**NPDES PERMIT FACT SHEET
INDIVIDUAL SRSTP/SRSTP**

Application No. PA0285153
APS ID 1093851
Authorization ID 1449152

Applicant Name	<u>Joseph Portera</u>	Facility Name	<u>Portera Properties SRSTP</u>
Applicant Address	<u>600 Hayden Boulevard</u> <u>Elizabeth, PA 15037-1600</u>	Facility Address	<u>869 Peninsula Drive</u> <u>Central City, PA 15926-9116</u>
Applicant Contact	<u>Carrie Eckenrod</u>	Facility Contact	<u>Same as Applicant</u>
Applicant Phone	<u>(412) 384-8170</u>	Facility Phone	<u>Same as Applicant</u>
Client ID	<u>378938</u>	Site ID	<u>866234</u>
SIC Code	<u>8800</u>	Municipality	<u>Indian Lake Borough</u>
SIC Description	<u>Private Households</u>	County	<u>Somerset</u>
Date Application Received	<u>July 27, 2023</u>	WQM Required	<u>Yes</u>
Date Application Accepted	<u>August 1, 2023</u>	WQM App. No.	<u>5623400</u>
Project Description	<u>Application for a new NPDES permit authorize a discharge of a treated Sewage.</u>

DATE: 8.30.2023
SCALE: 1"=50'
DRAWING: 537
LAYOUT: SFTF 1
SHEET NO.

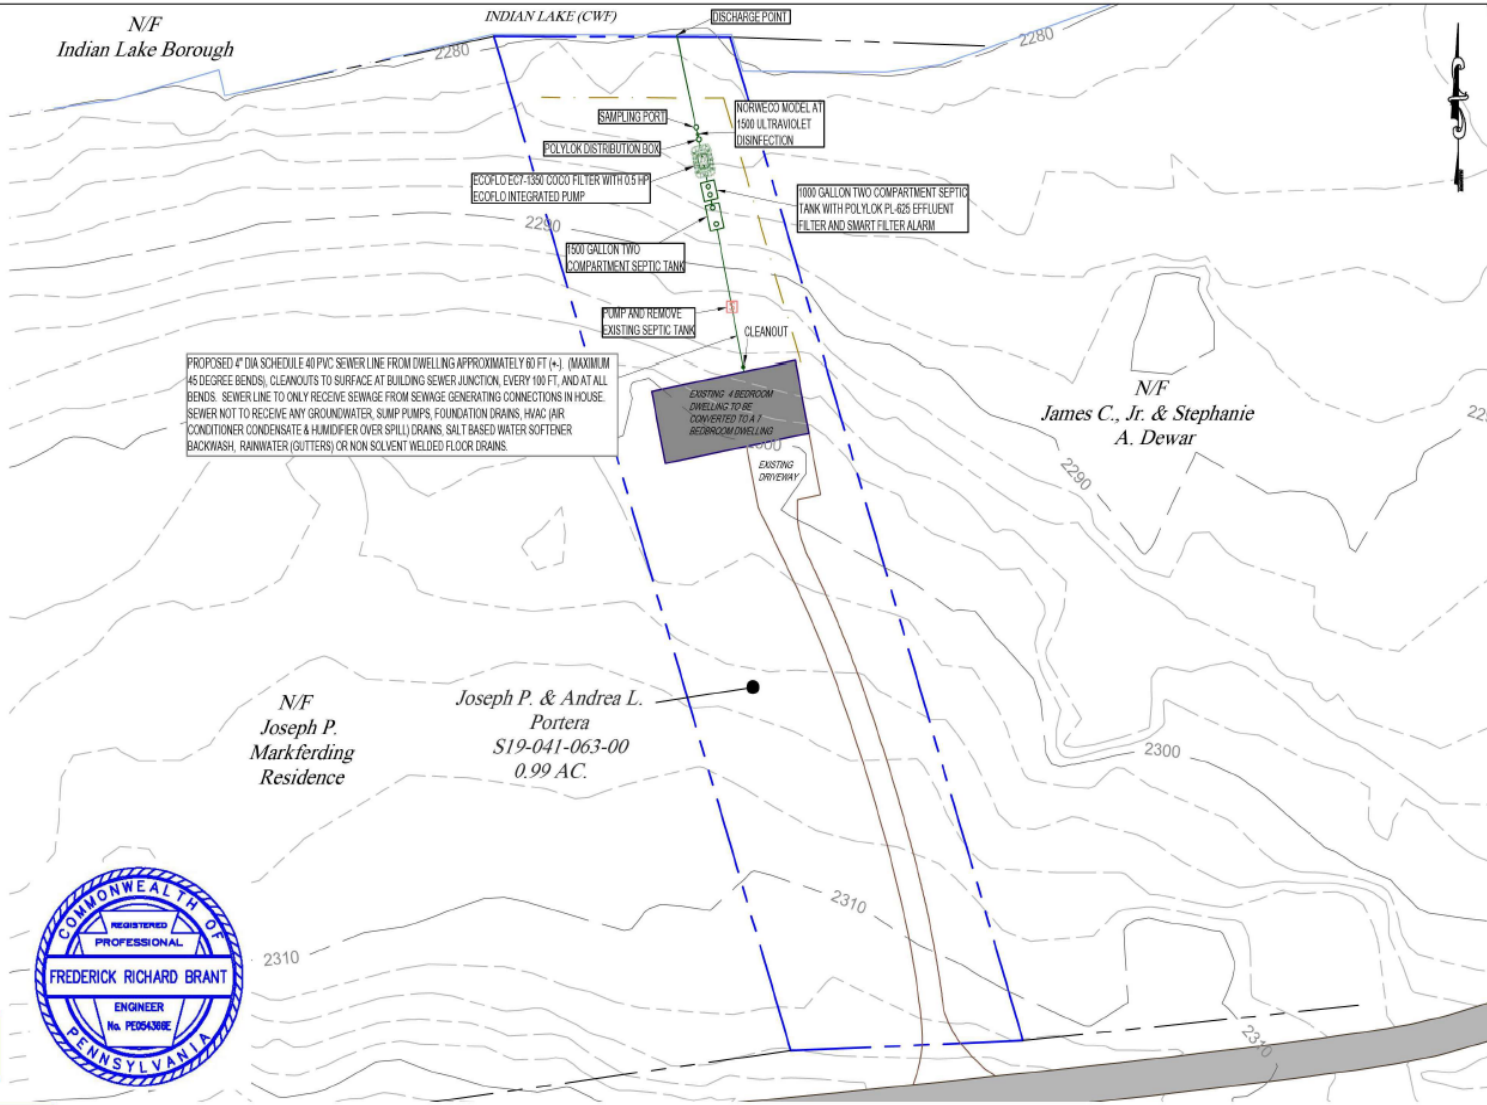
The Site Plans shows an average of 60 feet of a 4 in schedule 40 pipe that will deliver the effluent from the dwelling to the point of discharge (Indian Lake), which is located adjacent to the applicant property (see page 8, verified over eMap PA).

SHEET NO.
3-5

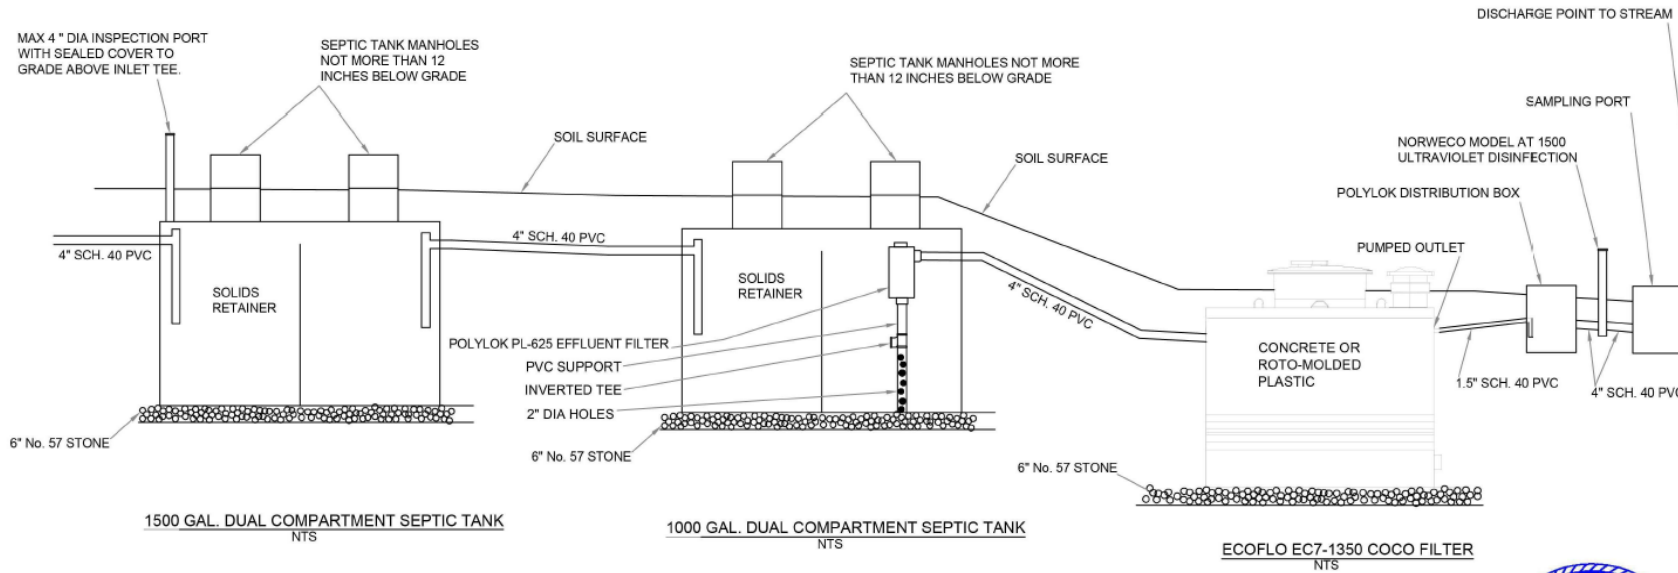
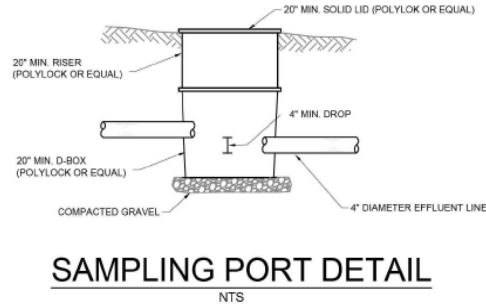
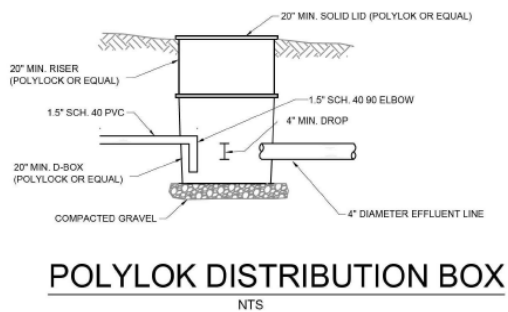
Checking on the effluent pump specs and operation, the 0.5 HP pump will generate a 49 inch of head that can travel a 75 ft of horizontal distance max. using a 1.5 Ø SCH 40 PVC pressurized pipe; the pump will deliver the produced head to the distribution Box. After that, the pipe size changes to 4 inches and the flow will be on gravity to the discharge point which is about 12 ft of distance (see page 9 of this fact Sheet).

Sampling should be grabbed after disinfection. Sampling Port is described under Sec. 2.6 on page 58 of the Owner's Manual, also can be checked over the unit drawings (see page 9).
